From: David Allen [dallen@aquascienceengineers.com]
Sent: Wednesday, December 19, 2007 4:11 PM
To: Wickham, Jerry, Env. Health
Subject: FW: Report for Project : ALBANY HILL. Kiff Project : 60062

ALBANY HILL MINI MART
800 SAN PABLO AVENUE
ALBANY, CALIFORNIA

Subject: Fuel Leak Case No. RO0000262 and Geotracker Global ID T0600102131, Albany Hill Mini Mart, 800 San Pablo Avenue, Albany, CA 94706 – Remedial Action Plan Approval

SUB-SLAB
VAPOR SAMPLING
POINT MAP

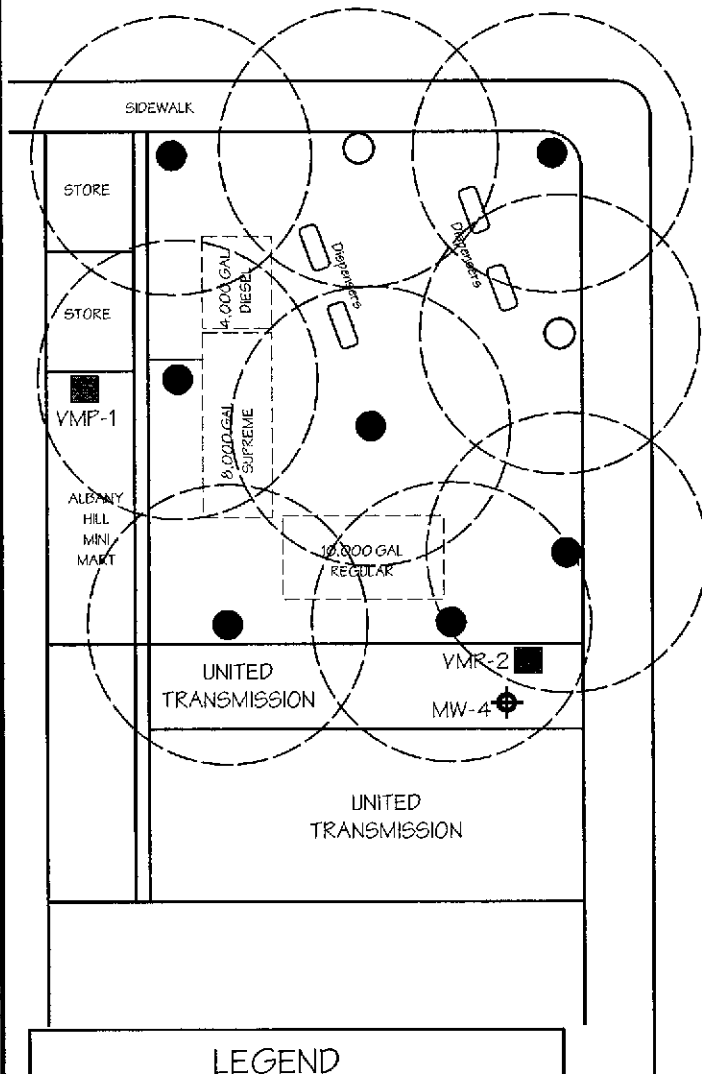
Thought I'd let you know what I found today at our Albany Hill site. I started by using our 580B Thermo Environmental PID inside the mini mart. The atmosphere showed a concentration of 0 ppm. I then measured the air within vapor monitoring point (VMP) #1 which is inside of the mini mart (see drawing). The atmosphere within VMP #1 showed a concentration of 0 ppm. I then traversed the service station (outside) and along the sidewalk in front of the station and United Transmission (UT). The atmosphere showed a concentration of 0 ppm. I then went inside UT in the area where VMP #2 is located as well as monitoring well MW-4. The PID began picking up concentrations of hydrocarbons as high as 45 ppm in the breathing area near the north eastern wall of UT. The PID measured 30 ppm and falling when placed adjacent to the well box on the floor that houses VMP #2. The PID measured 24 and falling when adjacent to several areas of weathered/cracked concrete floor near VMP #2 and MW-4. I then began traversing within the UT room to the west where the PID began measuring hydrocarbons as high as 398 ppm and climbing adjacent to UT's safety-solvent cleaning station which is approximately 25 feet west of VMP #2, inside the same room. The PID measured 188 ppm and climbing when adjacent to the bung opening of an aboveground waste-oil tank very near VMP #2. Finally, I removed the lid and sealed cap on VMP #2 and measured the atmosphere within VMP #2, which was a maximum of 114 ppm on the PID. Following the use of the PID, I collected a breathing zone airbag sample from the surrounding area near VMP#2 and monitoring well MW-4, followed by an airbag sample from within VMP #2.

My interpretation of the data that I collected using the PID today is that the subslab hydrocarbons that exist beneath UT (based on last weeks airbag samples; the results are attached) are not impacting the breathing zone within the UT building. The elevated PID concentrations are most likely the result of several components within the UT building, as detailed above. I would not be at all surprised if the airbag sample collected today from within VMP #2 contained much lower concentrations than the sample that was collected on 12-10-07. If that is the case, it could verify that the subslab hydrocarbons have always been there as a result of being so close the 10,000 gallon UST at the service station, and not the result of the ozone-sparging system increasing vapor concentrations. We'll know more when I get the results back.
